Re: G02019763 – Lot 102 Bay Highlands - Variance Request

BAY HIGHLANDS LOT 102

VARIANCE PLANS

OFFICE OF PLANNING AND ZONING

DEVELOPED CONDITIONS

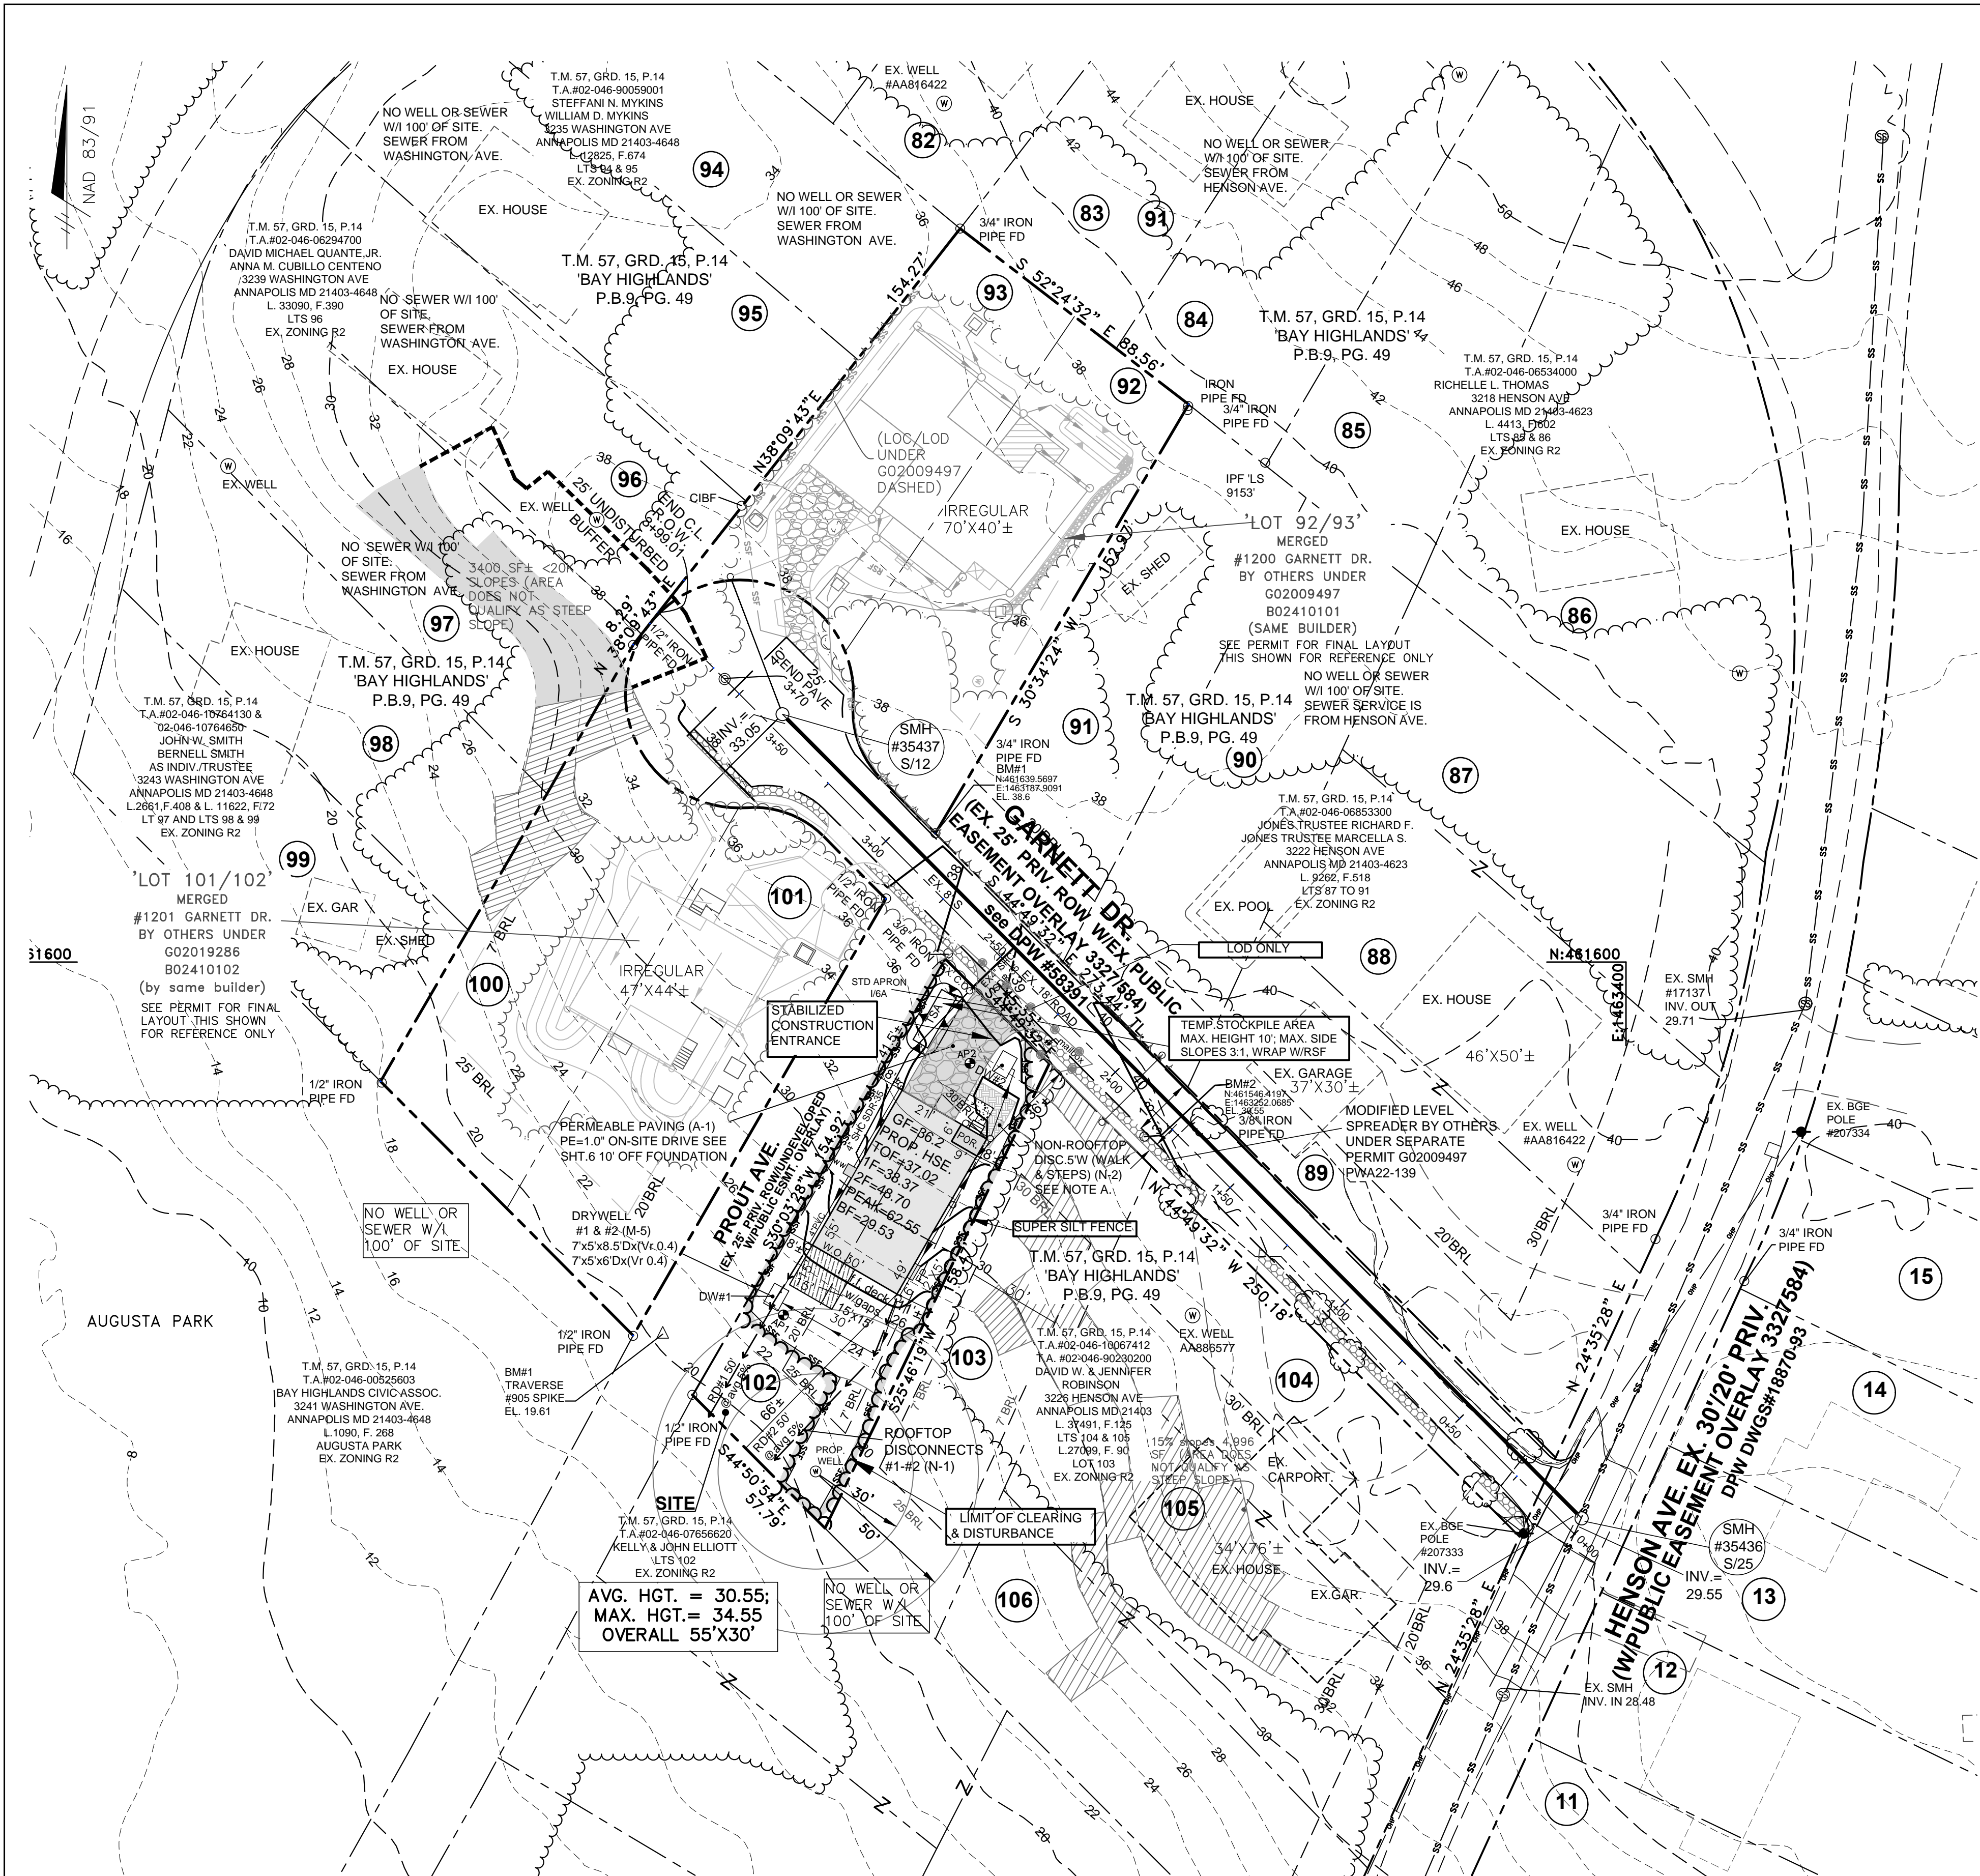
The site plan should be updated to show the correct side corner setback.

- 1) Add the height in stories and feet to the site plan in the area of the proposed dwelling.
- 2) Correct the corner side setback to 20' per R2 bulk regulations
- 3) Page 2 under General Notes 2. Fix corner side to be 20' not 25'
